Friends of Siamese Ponds North River, NY

December 10, 2021

FOSP COMMENTS ON OCTOBER 15, 2021 BARTON MINE PERMIT APPLICATION

Photo 13A. View from Thirteenth Lake road looking west towards the Ruby Mountain Mine site (55mm lens)

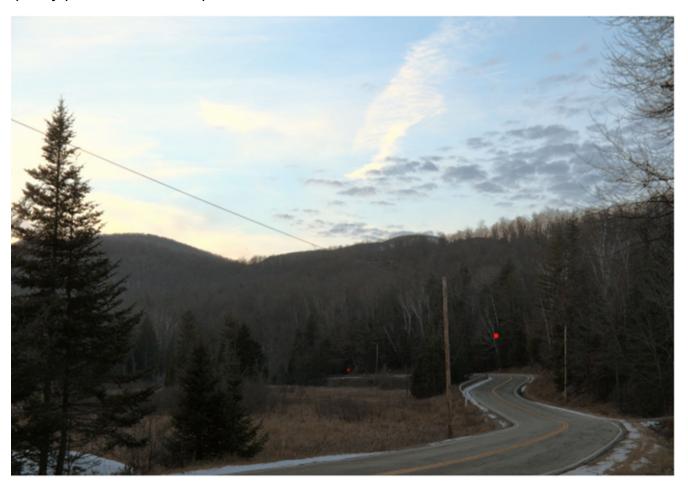
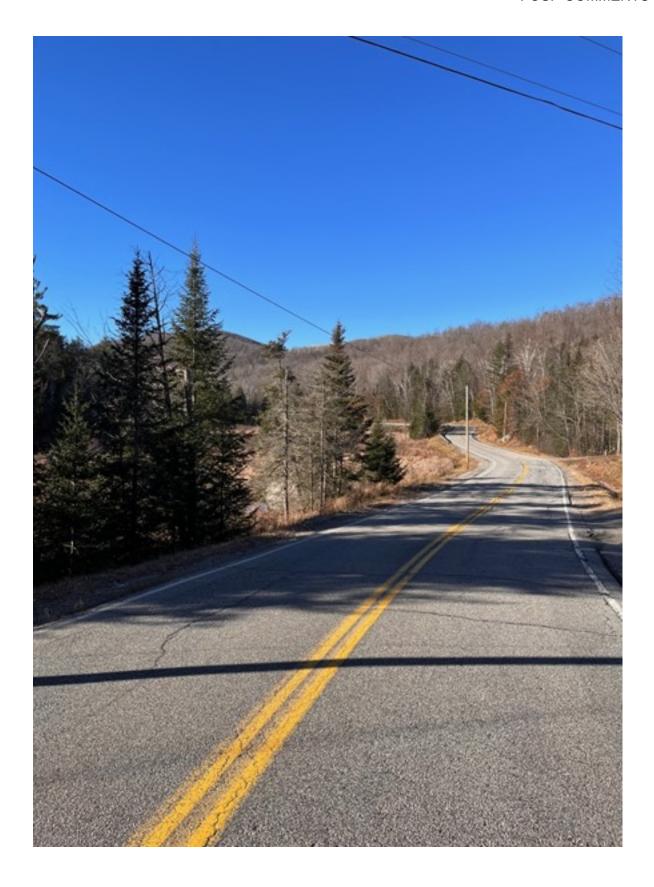
12. <u>Viewshed Impacts</u>. Many of the photos presented in the Viewshed Analysis (Appendix O) are either hazy or backlit, making analysis of potential impacts more difficult. For example, compare the views below of the Appendix O backlit photo of the mine from 13th Lake Road versus a recent sunlit photo from the same location. Better quality photos should be provided.
